## Avolites LTD Engineering Change Notice

ECN title	Q3 server – R2-VIDEO board link mod		
ECN Number	ECN-212		
Related Product(s)	All Q3 servers before Q3-00045		
Date / Author	01/11/2018	Grzegorz Ksiązka	
Reasons for ECN	DP output not able to drive active converters		
Parts required	Resettable fuse 500mA, 1A 60V PN 10-02-0052 30AWG mylar covered solid core wire PN 04-03-0062		
Tools required	Solder iron station, side cutters, silicon gun		
Estimated time	15 Minutes

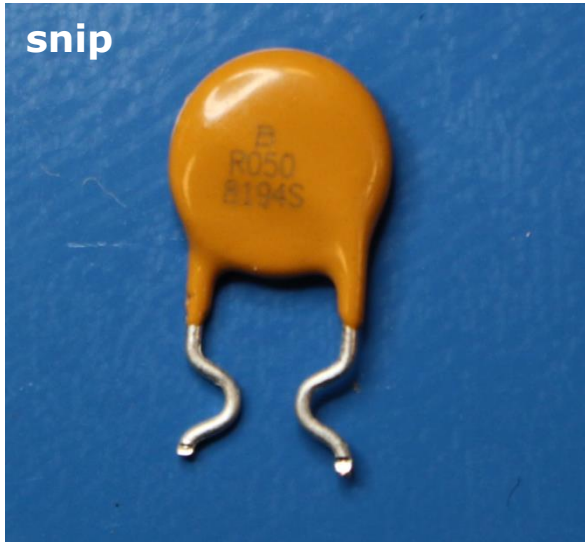
- Cut 20mm off 30Awg mylar covered solid core wire  
Strip off 1mm insulation on both ends

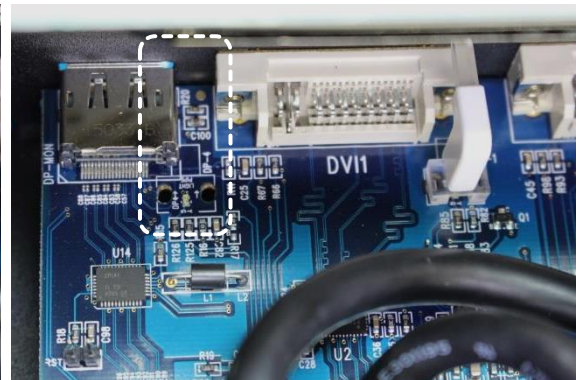
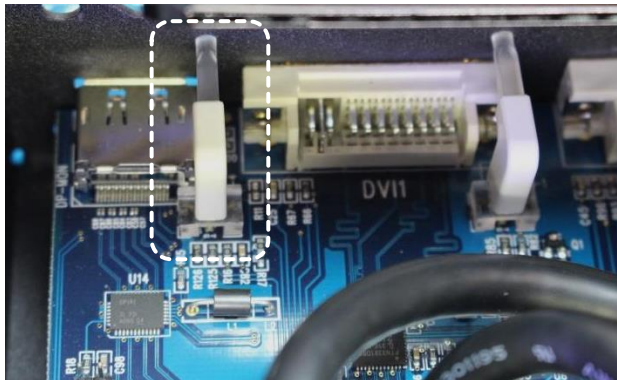
- Snip of the legs of the resettable fuse 500mA, 1A 60V and bend them out to the shape shown below

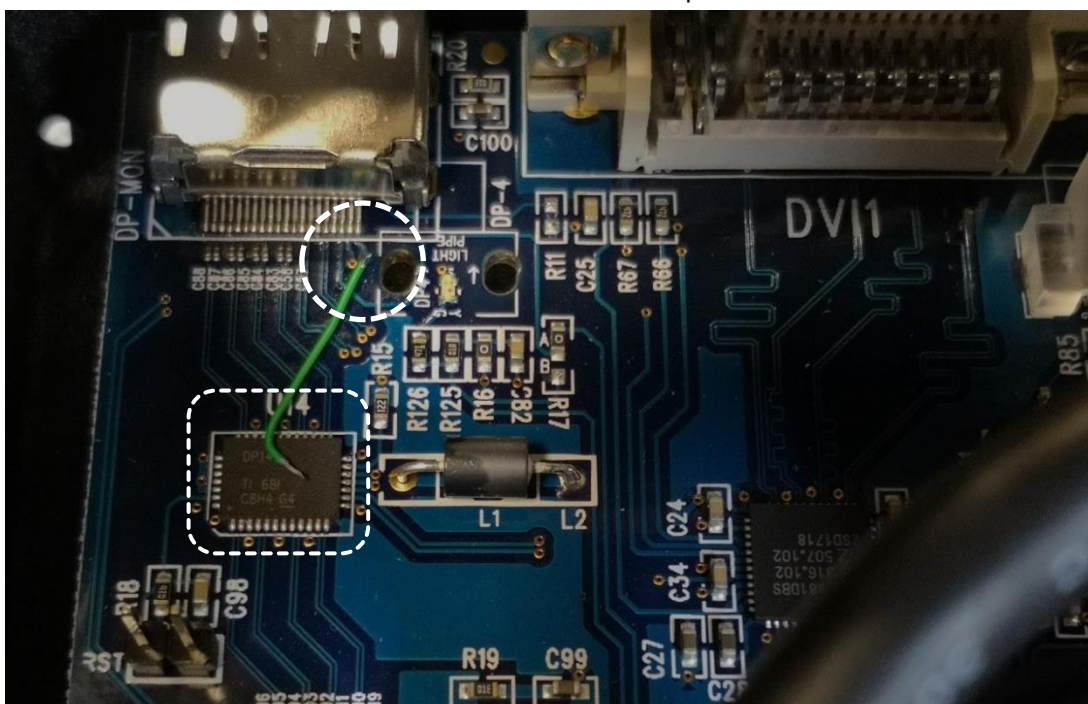
5. Locate the right most Via behind the DP output (arrow)

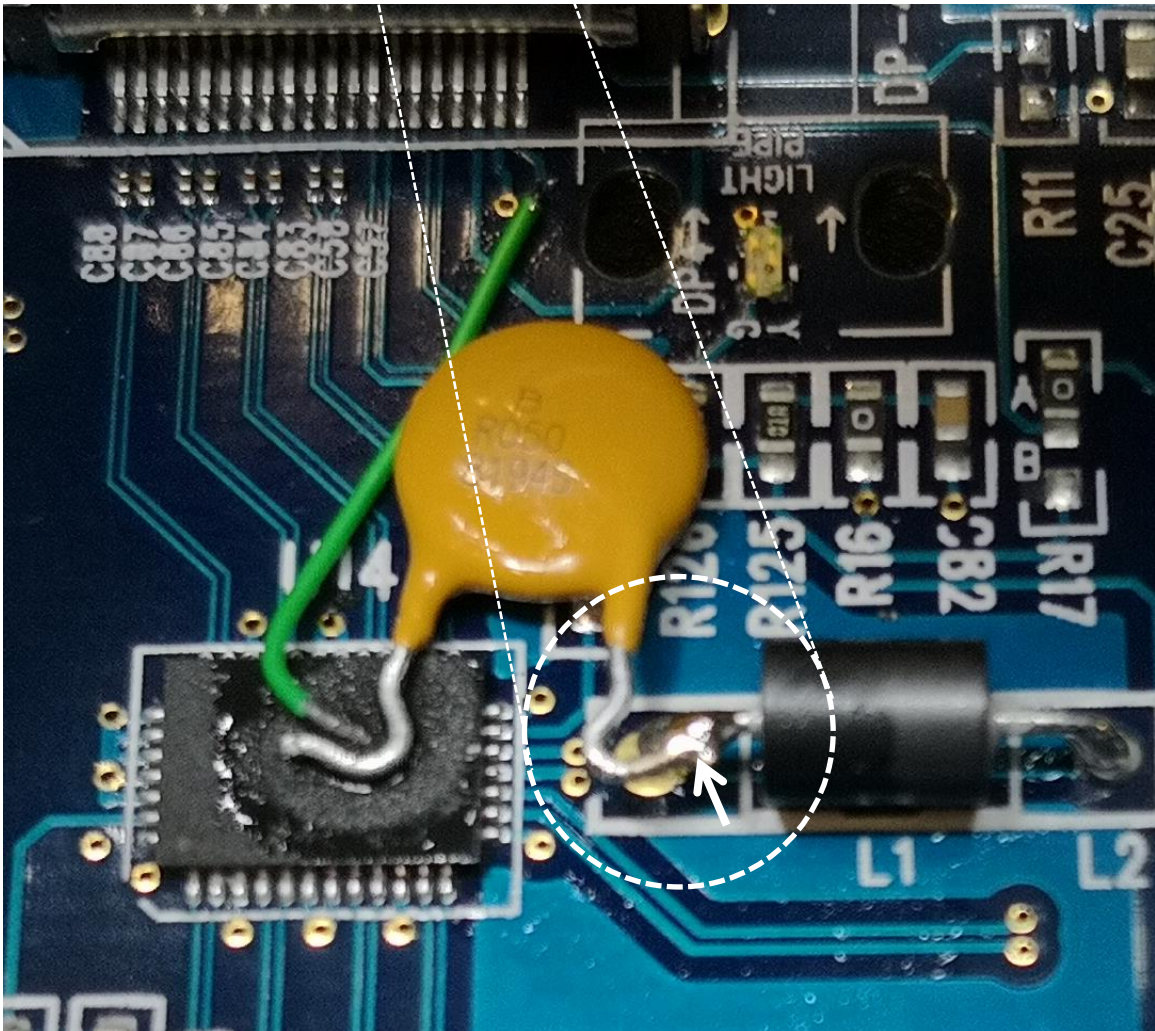
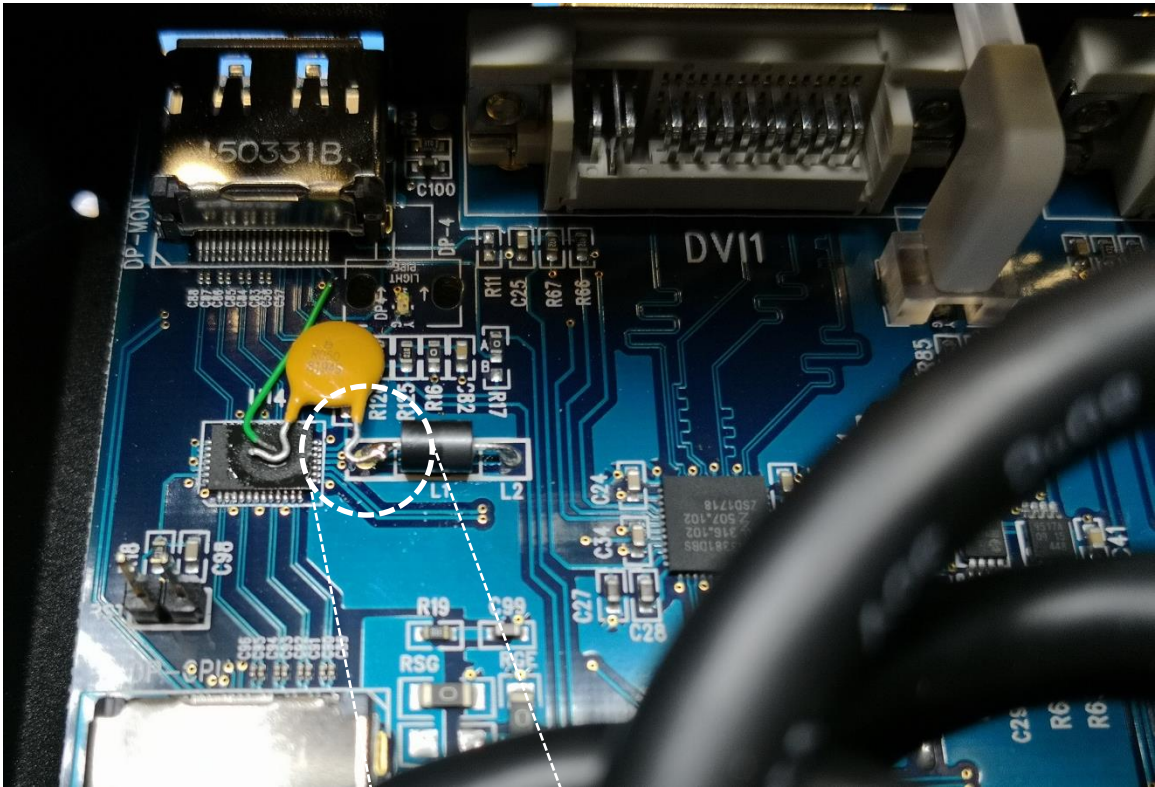
6. Insert the prepared 30 AWG wire and solder  
MAKE SURE TO HAVE THE SOLDERING IRON AWAY FROM THE OTHER VIA...  
Place the other link end on the dead centre of the U14 chip

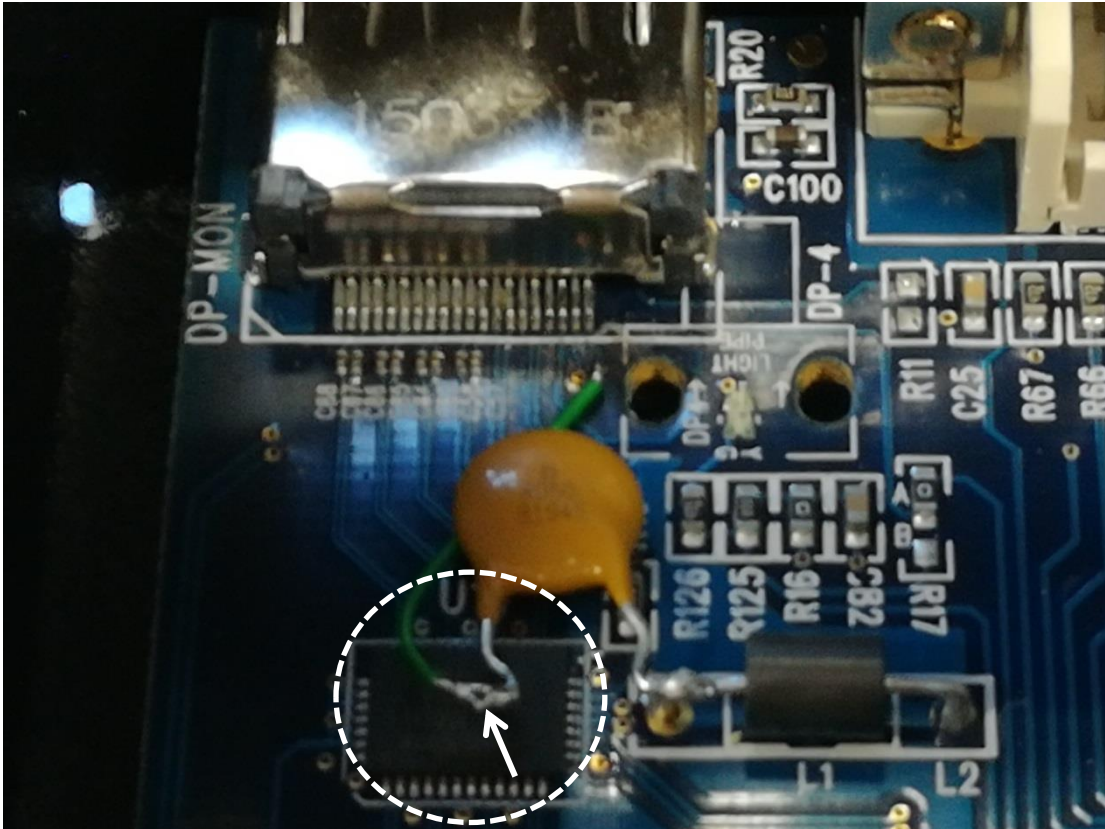
7. Solder the prepared resettable fuse to L1 nearest to the IC

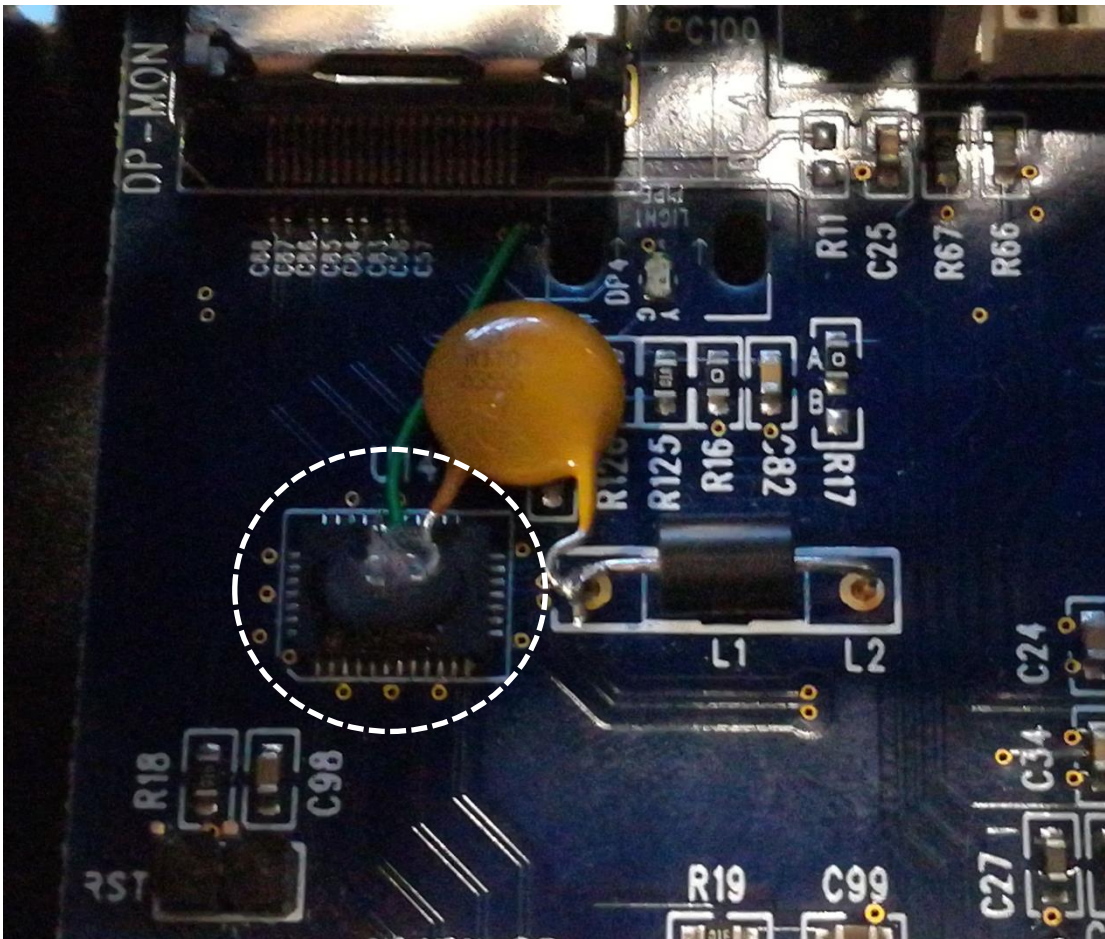
8. Solder the wire to the other side of the resettable fuse, and make sure it lays flat on the IC

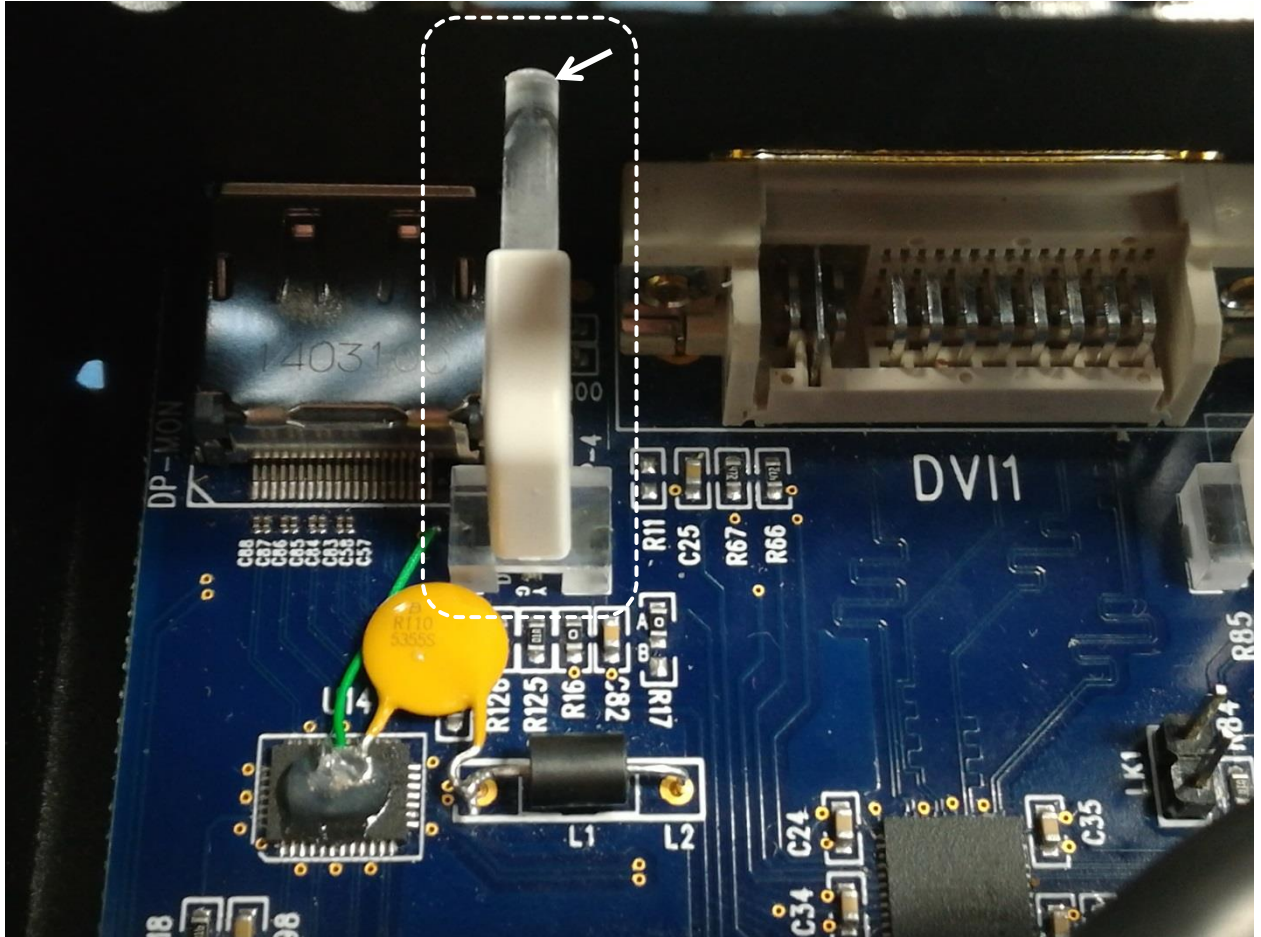
9. Apply a bit of silicon to the assembly, NOT covering the pins
